Application by
Fingal County Council
for Waste Licence Application W0231-01
for Fingal Landfill, Co. Dublin

***Replies to Request
for further information in accordance with
Article 14(2)(b)(ii) of the Waste
Management Regulations***

January 2007

Article 14 Information

GROUNDWATER FLOW MAPS

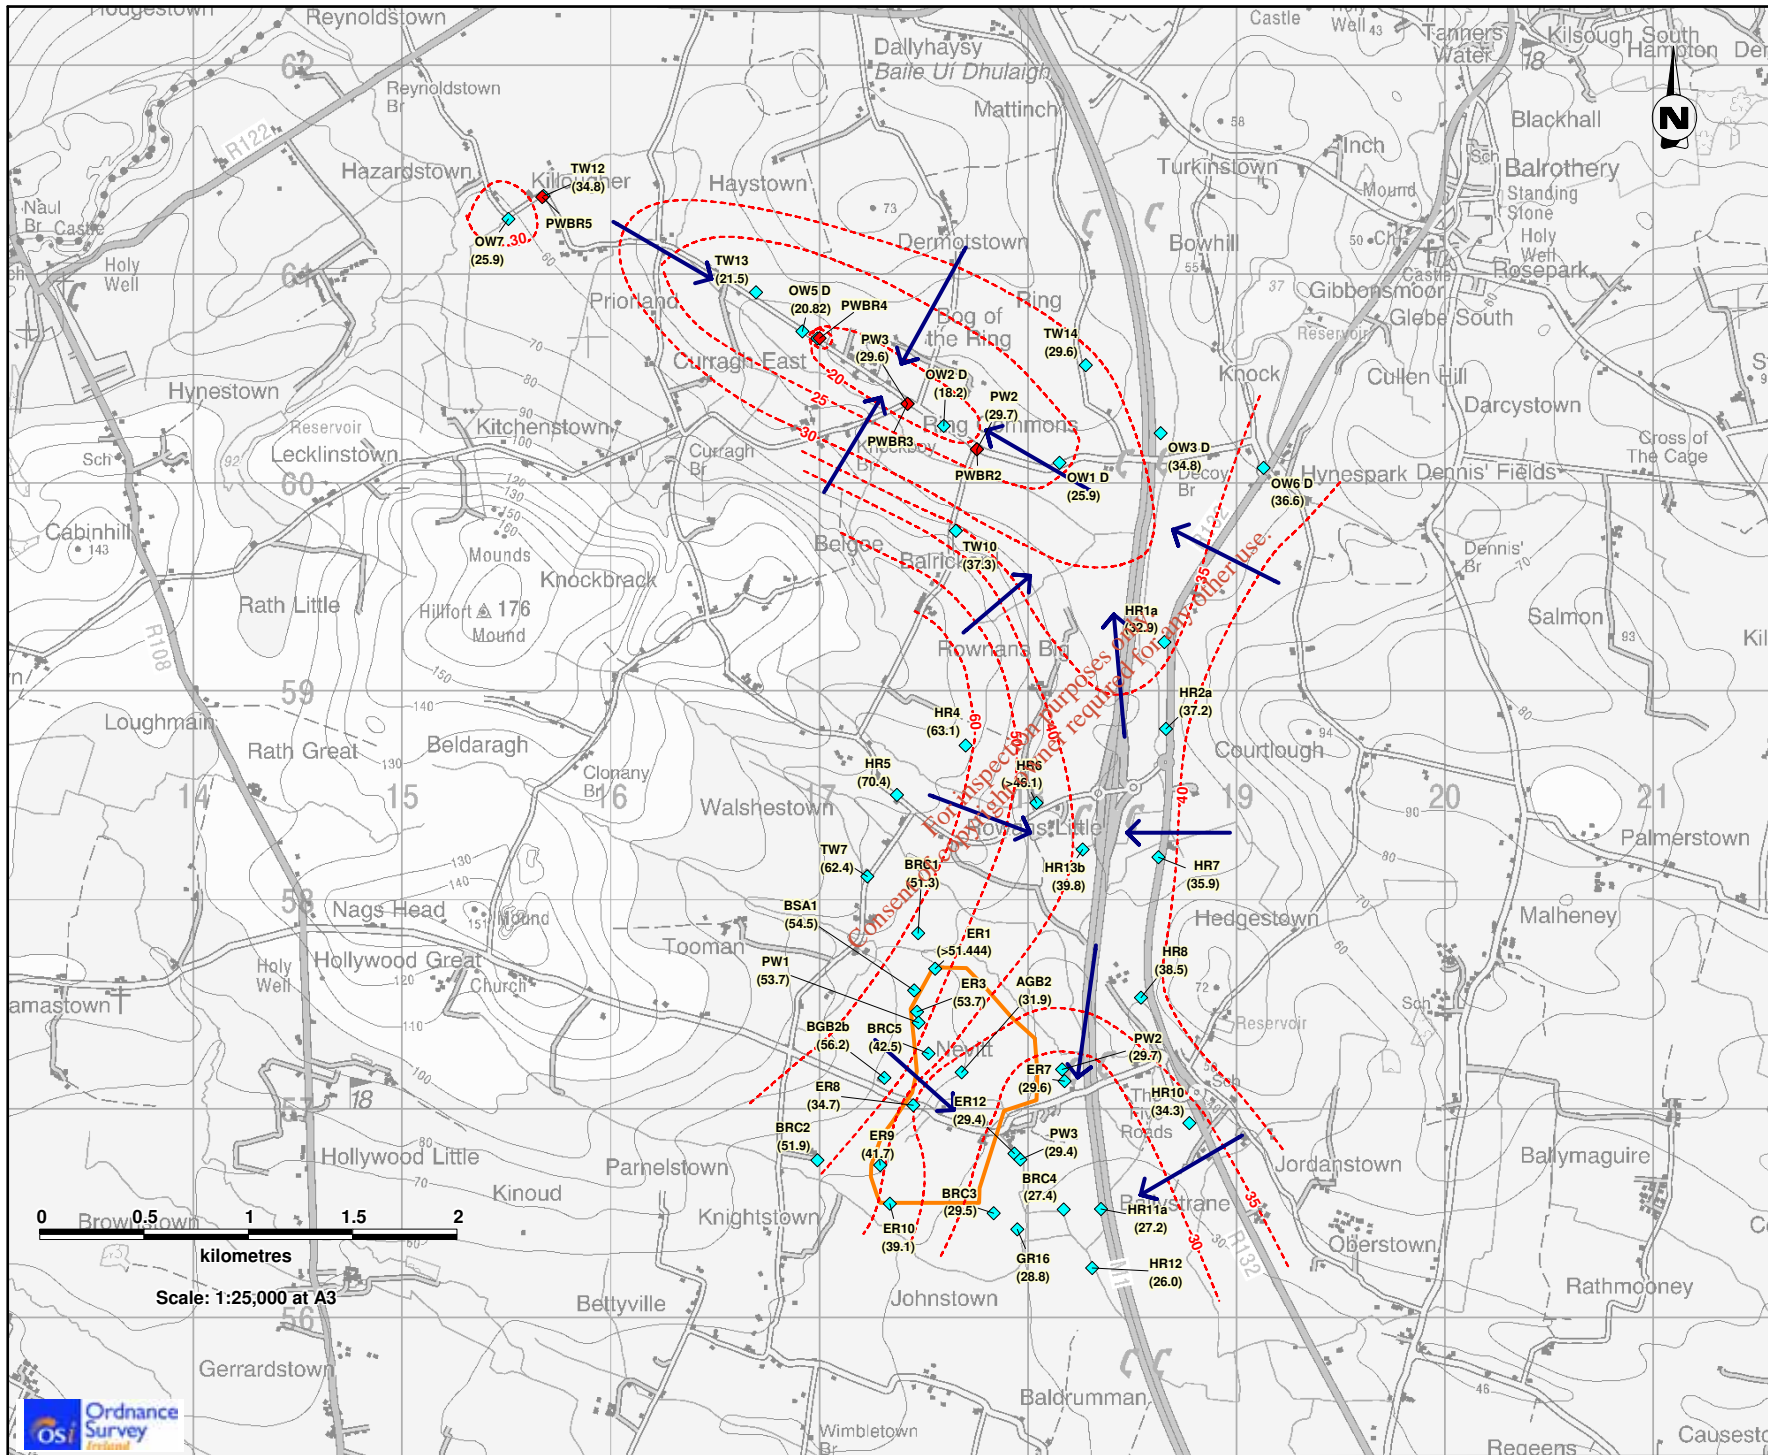
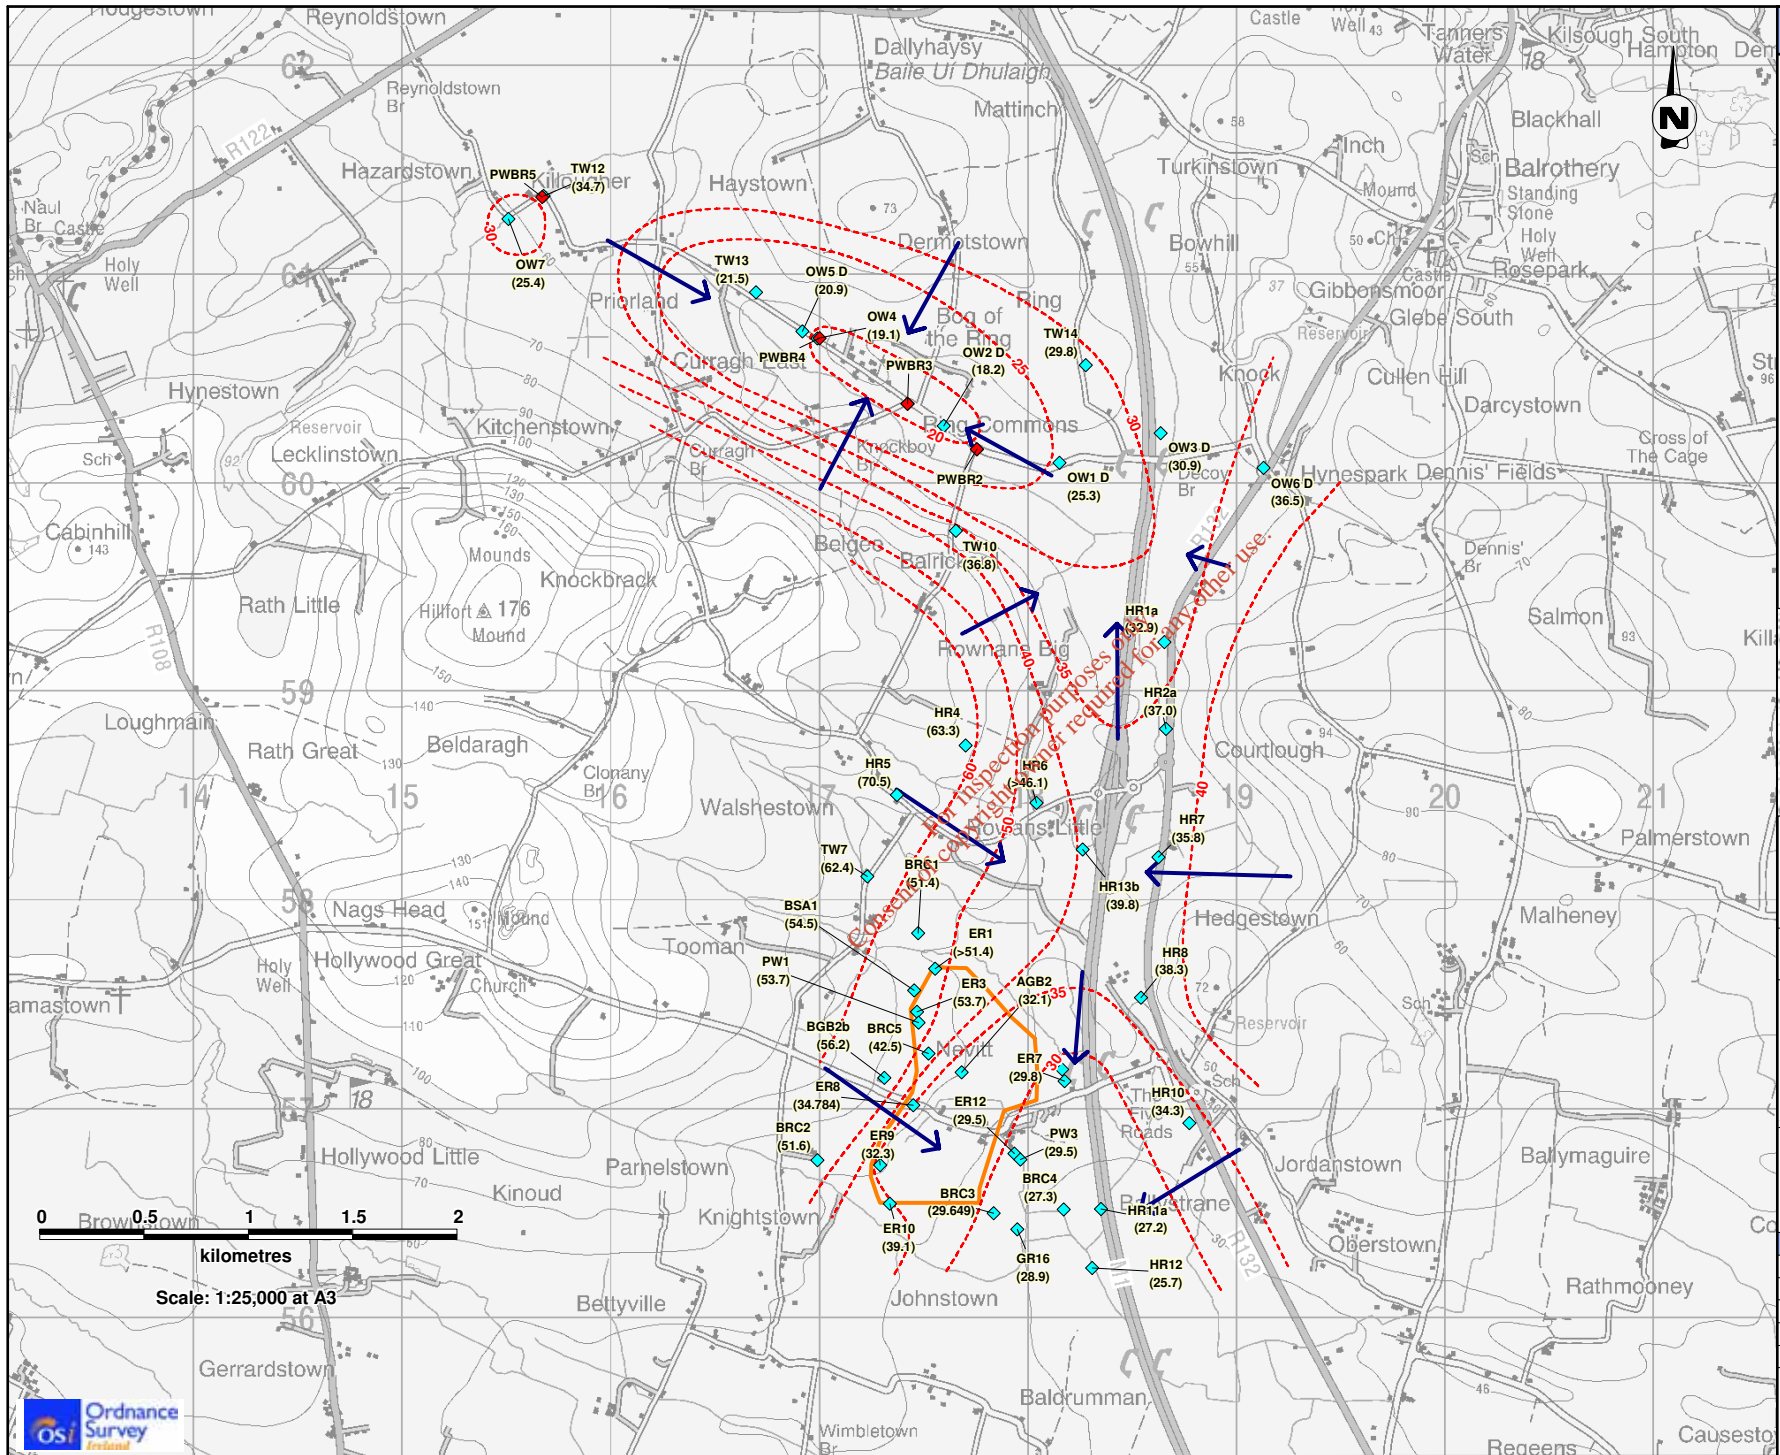
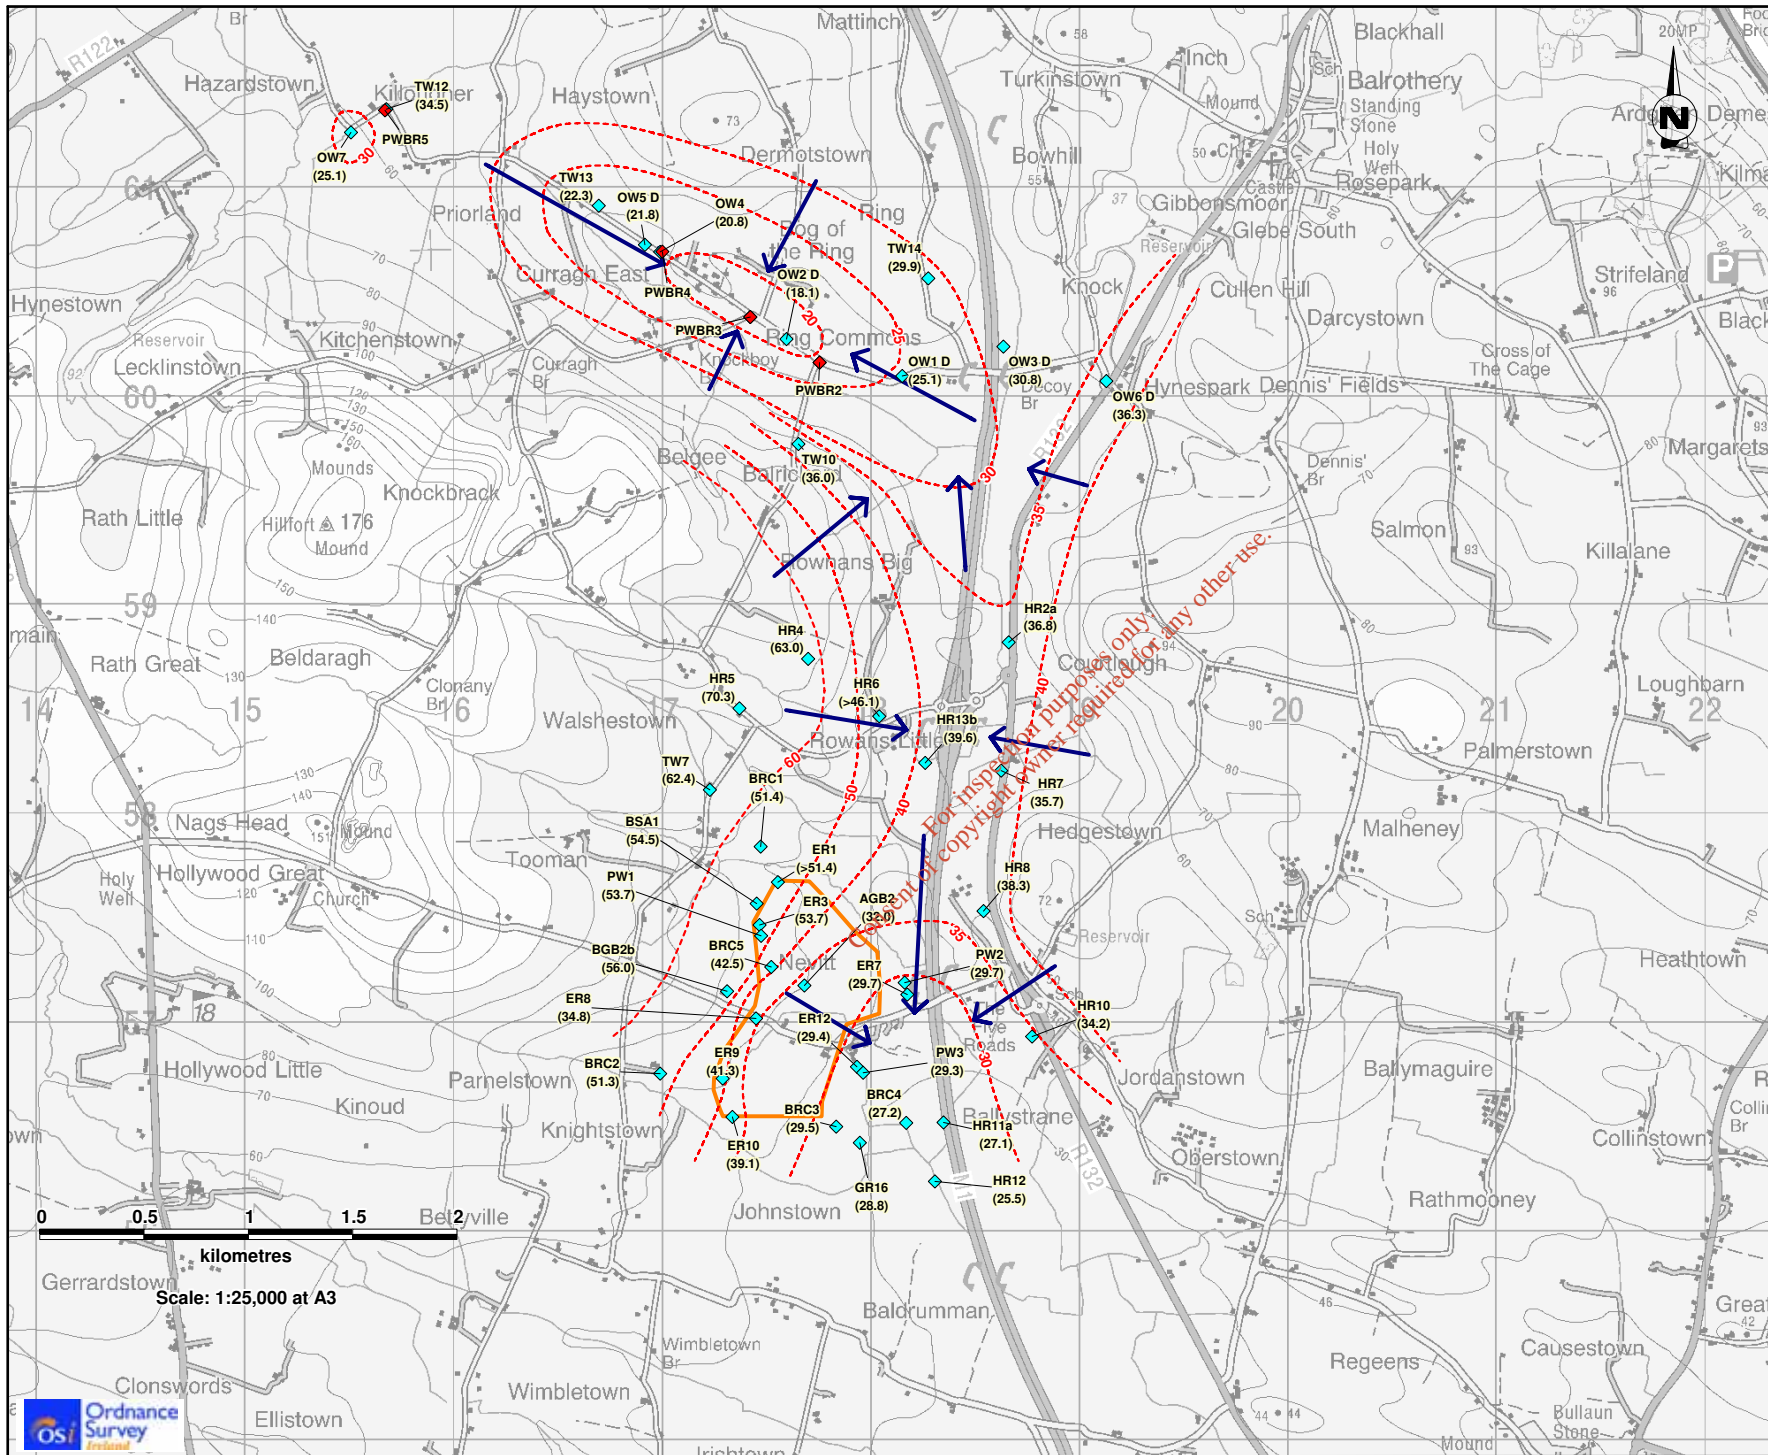
The notice issued by the EPA on October 11th 2006 regarding Article 14 (2) (b) (i) of the Waste Management Licensing Regulations, *Section 1.4 (ii) required a more rigorous assessment of the groundwater flows in the area of abstraction wells P1, P8 and P10.*

Groundwater flow maps are provided in **Appendix 6**. The direction of groundwater flow under the proposed site and local surrounding area has been established from comprehensive time series groundwater level monitoring data. Water level monitoring data sets collected from June 2005 to December 2006 have consistently demonstrated that groundwater flow below the proposed landfill site is in a south-easterly direction towards Rogerstown Estuary and away from the Bog of the Ring through all seasons.

Further to our response to the first notice submitted on the 19th December 2006 in relation to Article 14, a contour map for December 2006, which includes data for Kerrigan's well, is included in **Appendix 6**. It can be seen that the overall groundwater flow direction in that area is to the south east and away from the proposed landfill site. This is consistent with the overall groundwater flow pattern for the area and any groundwater originating beneath the landfill is not likely to flow towards Kerrigan's well.
